CitiPower/Powercor Technical Standards Update for November 2020

EB Series – EB141

GS Series – Circular Service Pit and Parallel Pillar

VI Series – 1x1000kVA Standard Substation Design

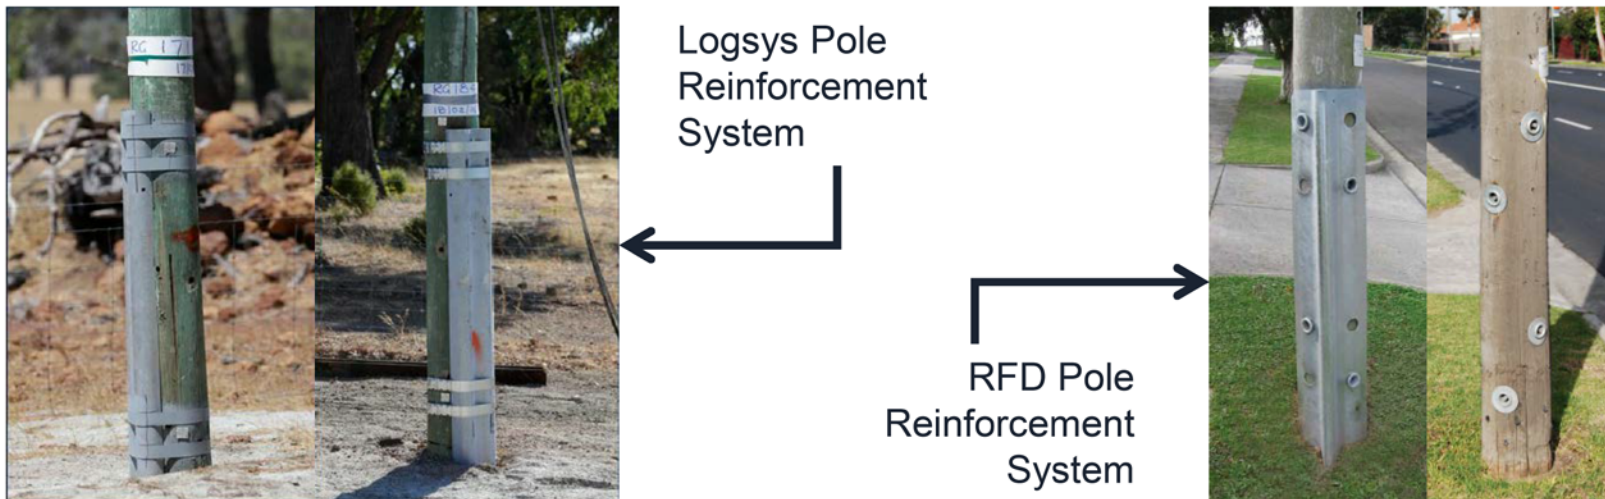
- Technical Standard EB141 – Pole Reinforcement Systems has been updated to include the Logsys Osmose pole reinforcement system.
- Logsys Osmose reinforcement is a non-invasive system that utilises a banding method of attaching steel trusses to the pole. The Osmose product has been in existence for over 50 years in the USA.
- The current ReinForced Design (RFD) nail reinforcement system is still approved for use.

Figure 1 – Standards GS021 & GS201

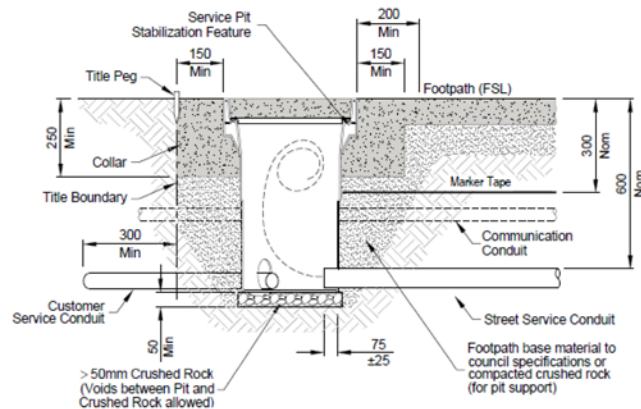
- Technical Standards GS021 and GS201 have been updated with changed installation requirements for the circular service pit in footpaths and driveways. These include a larger concrete collar and changes to the crushed rock requirements beneath the pit.
- Technical Standards GS021 and GS211 have been updated with greater dimension details.

- Service installations changes are to allow for additional stability features and changes to Material ID 350024 which have been advised in MCA7-20. The stability features and a thicker concrete collar are intended to reduce the chance of service pits moving from the level of the surrounding footpath.
- Changes to pillar standards were requested by the field auditing team to clarify requirements for pillar installations.
